Access Compliance Report

Public Rights-of-Way

(Curb Ramps)

Intersection ID: 8793	Main Street: BARRINGTON_DR	Cross Street: WOODFIELD_DR	Location: S
ADA ID: E86068048AEA	Ramp Type: Perp	Initial Pass/Fail: Fail	Overall Compliance: No
Severity Score: 1.25			
Codes/Mitigation Info/Possible Solution		Field Measurements/Component Compliance

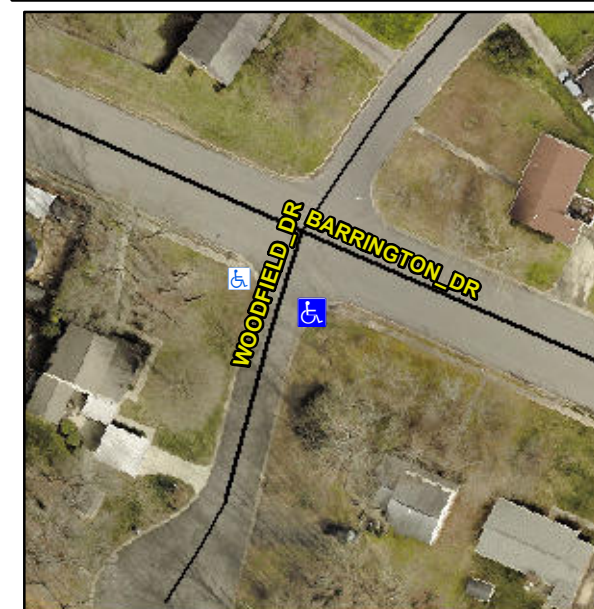
Not Found, R304.5.3

Compliance	Description	Data	Compliance	Description	Data
N/A	Ramp Length (in)	25.0	Yes	Ramp Slope (%)	5.2
Yes	Ramp Width (in)	48.0	No	Ramp XSlope (%)	2.2
N/A	Flare Type LT	N/A	N/A	Flare Type RT	N/A
N/A	Flare Slope LT (%)	N/A	N/A	Flare Slope RT (%)	N/A
N/A	Flare Traversable LT?	N/A	N/A	Flare Traversable RT?	N/A
N/A	Landing Length (in)	N/A	N/A	DWS Provided?	N/A
N/A	Landing Width (in)	N/A	N/A	DWS Contrast?	N/A
N/A	Landing Slope (%)	N/A	N/A	DWS Length (in)	N/A
N/A	Landing X Slope (%)	N/A	N/A	DWS Full Width?	N/A
N/A	Landing Curb? (Y/N)	N/A	N/A	DWS Offset (in)	N/A
N/A	Shared Landing?	N/A			
N/A	Gutter Ponding?	N/A	N/A	Gutter Slope (%)	N/A
N/A	Gutter Lip Ht (in)	N/A	N/A	Gutter X Slope (%)	N/A
N/A	Painted X Walk1?	No	N/A	Painted X Walk2?	N/A
	X Walk 1 Direction	To NW		X Walk 2 Direction	N/A
N/A	X Walk 1 Width (in)	N/A	N/A	X Walk 2 Width (in)	N/A
	X Walk 1 Slope (%)	1.1		X Walk 2 Slope (%)	N/A
	X Walk 1 X Slope (%)	0.3		X Walk 2 X Slope (%)	N/A

Remove & Replace Entire Ramp.
